Re: Cover Letter

Applicant: TagMaster AB

FCC ID: M39LRXX

This affects the 612669 07 Schematic Diagram RF board.

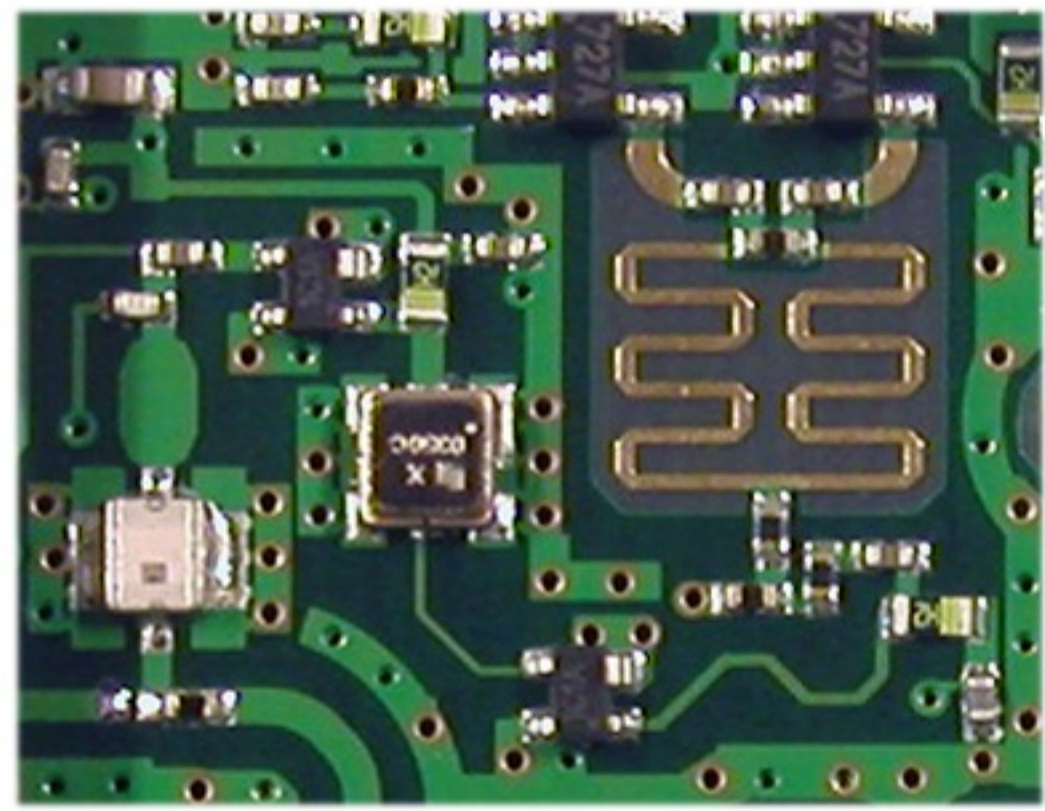
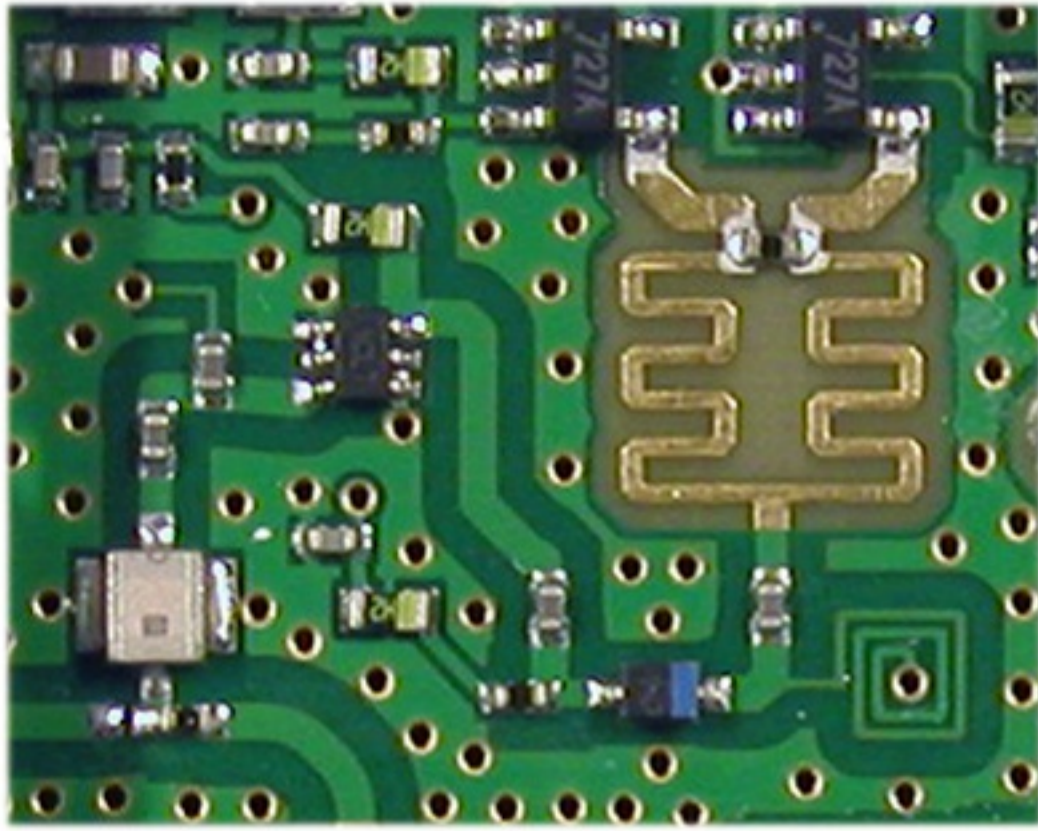
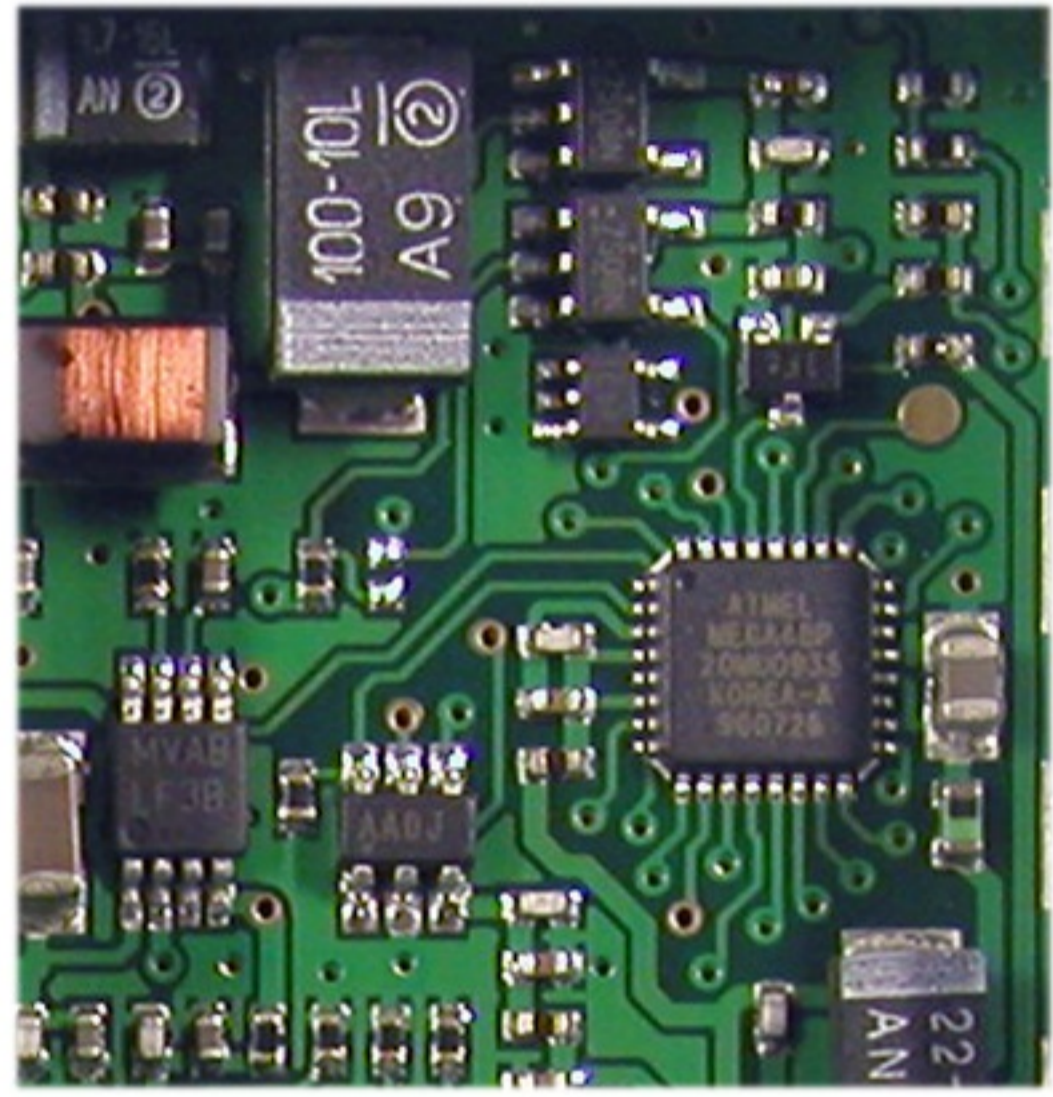
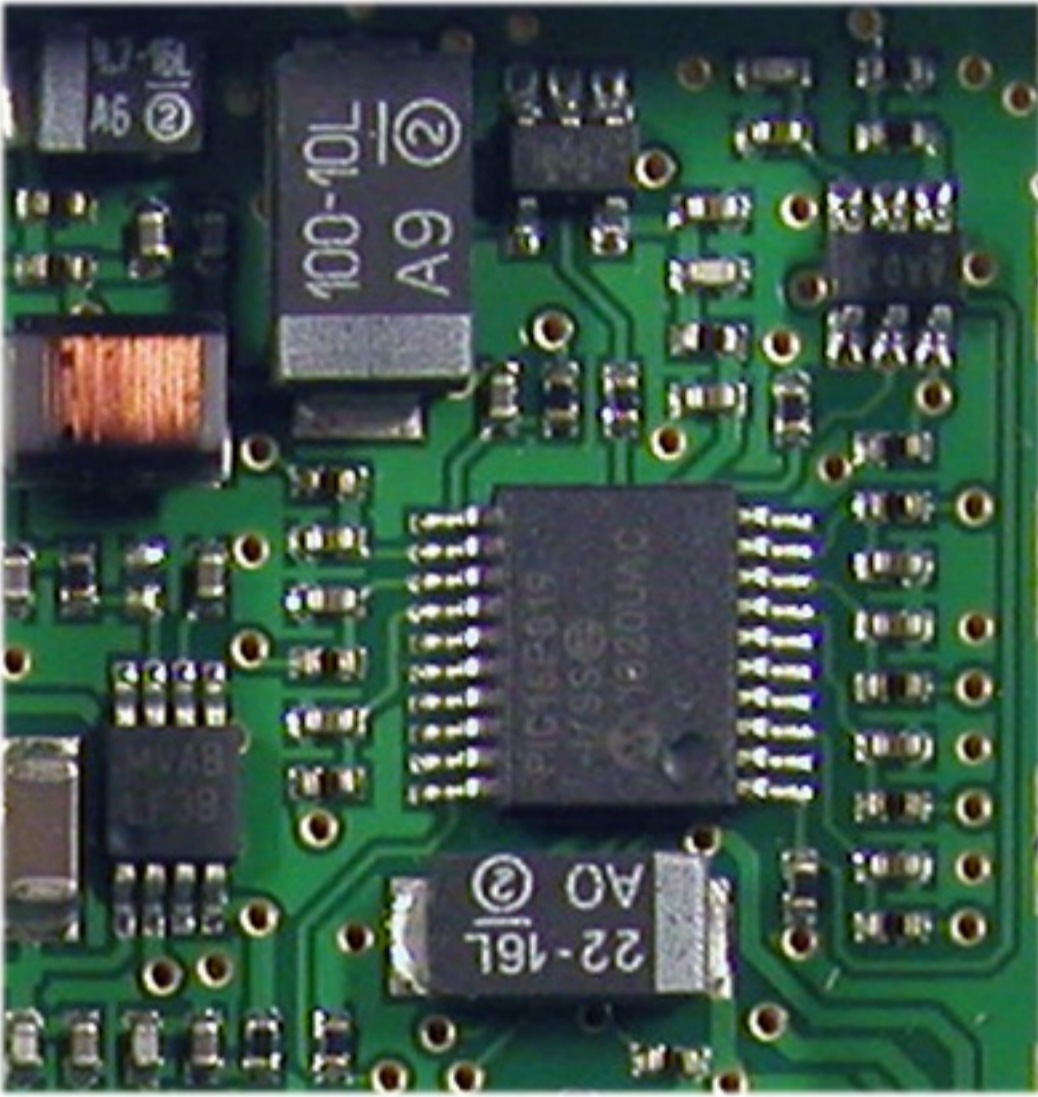
Due to 'last time buy' notification of a component used in the design, a minor update of the design has been made. This affects all products under the FCC ID: M39LRXX, namely S1566, LR-6 and HR-2. The modification is chip replacement of a portion of the transmitter that performs the sub function of frequency determination (PLL Synthesizer) in compliance to 'Part substitution' in the Permissive Change Policies. At the same time, the design was updated according to variations in electrical construction as of changing a micro processor and adding an additional receiver filter with corresponding amplifiers to meet European updated immunity requirements as of ETSI EN 301 489-1 v1.8.1. These changes meet the rules in Section 2.1043 as they do not affect stabilizing circuits, frequency multiplication, basic modulator or maximum power or field strength.
